**RE: MP 07_0010 – Environmental Assessment for Concept Plan and Stage 1 Project Application
Lot 4 DP 615261, Lot 1 DP 374315 and Part Crown Reserves R.82555 + R.754444, Ocean Drive Lake Cathie**

**RE: MP 07_0010 - ENVIRONMENTAL ASSESSMENT FOR CONCEPT PLAN AND
STAGE 1 PROJECT APPLICATION
LOT 4 DP 615261, LOT 1 DP 374315 AND PART CROWN RESERVES
R.82555 & R.754444, OCEAN DRIVE, LAKE CATHIE**

PROJECT NO:	4898	DRAWING TITLE:	EXHIBIT 06E - WESTERN BOUNDARY EDGE TREATMENT		
DA NO.:		PROJECT:	PART 3A CONCEPT PLAN APPLICATION LOT 1 DP374315 AND LOT 4 DP615261 OCEAN DRIVE, LAKE CATHIE		
DESIGNED BY:	AJT	CLIENT:	MILLAND PTY LTD & SEAWIDE PTY LTD	DRAWING NO:	4898P_WesternEEC
DRAWN BY:	MW			SHEET:	1
CHECKED BY:	AJT			REVISION:	C
DATE CREATED:	APRIL 2011

Figure 2. Vegetation Communities

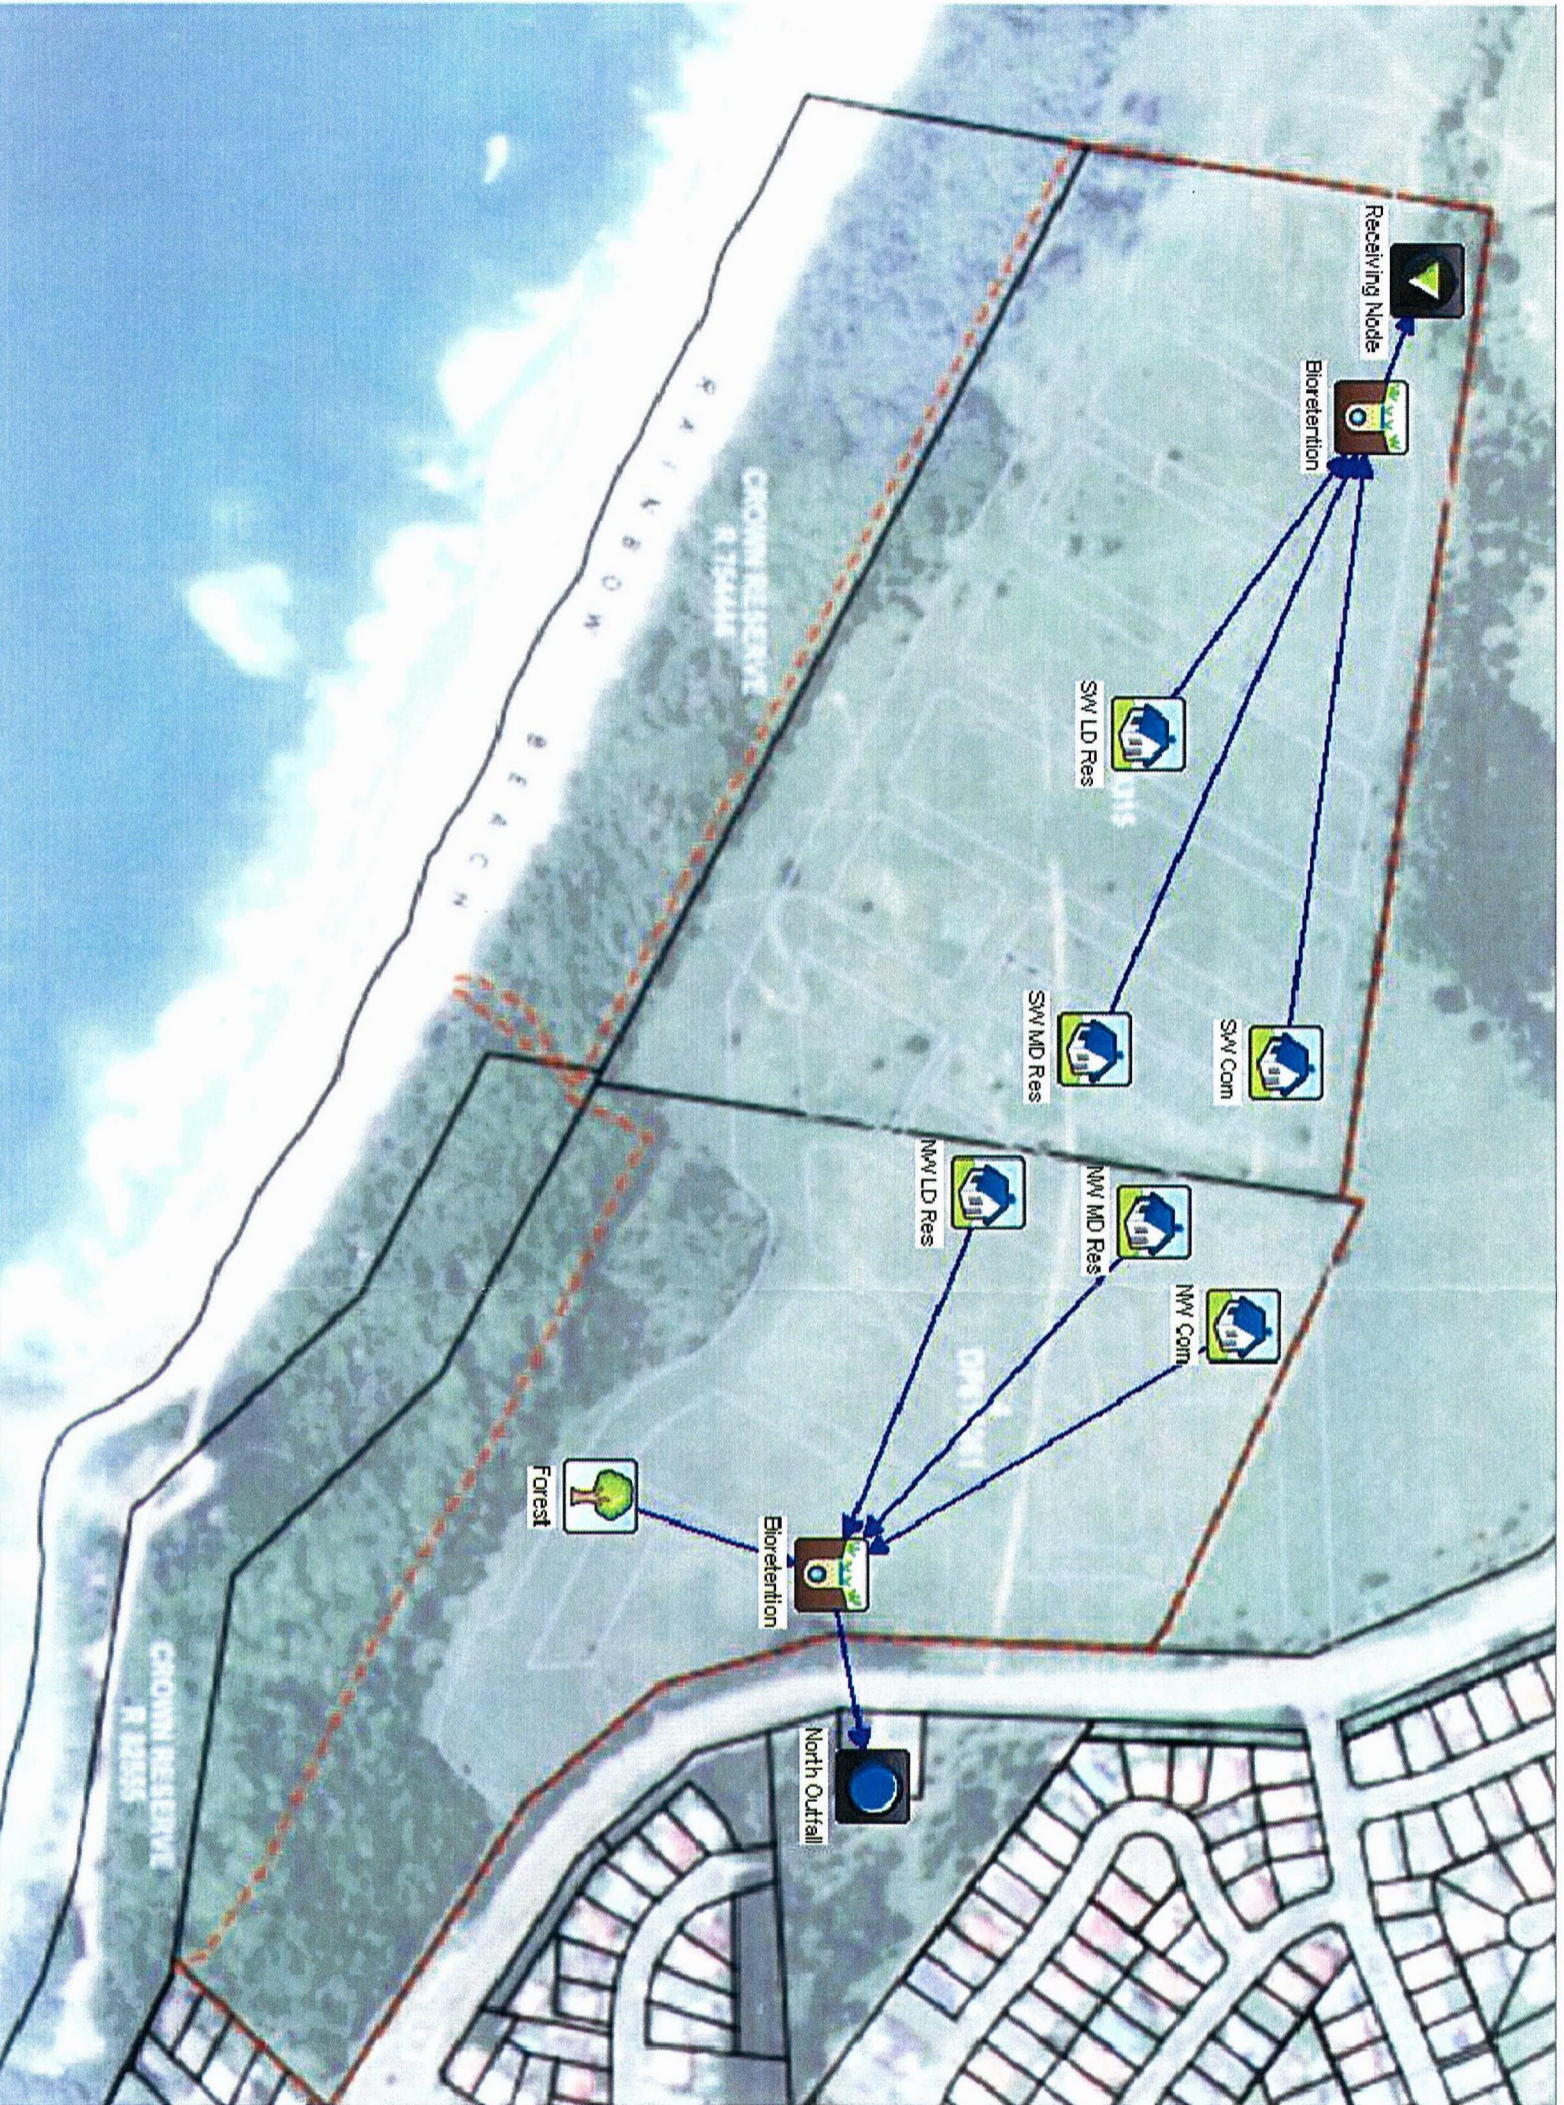
Our vegetation mapping of the subject area referred to firstly identifies a linear stand of native vegetation that loosely follows the central upper catchment drainage line of Duchess Creek. As detailed in our vegetation map (Figure 2) accompanying the Area 14 Koala Plan of Management, the majority of this vegetation was classified by us as Swamp Oak Forest, our mapping further indicating (as indicated by double asterisk) that we considered this community to satisfy the physiognomic and floristic criteria supporting recognition as the Endangered Ecological Community (EEC) *Swamp Oak Floodplain Forest on the NSW North Coast, Sydney Basin and South East Corner bioregions*.

Towards the southern extremity of the Swamp Oak Forest (and where Duchess Creek traverses the southwestern corner of the Milland & Seaside property) we also mapped a small patch (ca 750 – 800m²) of rainforest. We considered this community to satisfy the physiognomic and floristic criteria of the EEC *Littoral Rainforest in the NSW North Coast, Sydney Basin and South East Corner bioregions*. I am aware that Mr. Peter Parker holds a slightly different view, considering the community to instead better constitute a form of riparian rainforest. Regardless, there is no dispute between Mr. Parker and I that the vegetation in question is rainforest; it is thus an EEC by any measure. In this regard I feel obliged to draw your attention to the last paragraph in Sec 5 of the NSW Scientific Committee's Final Determination regarding the listing of Lowland Rainforest in NSW North Coast and Sydney Basin bioregion, vis

Hence, in response to the matter raised in Mr. Enguang's e-mail of the 23rd March, I reiterate that view inherent in our mapping that both of the aforementioned vegetation communities are both EECs.
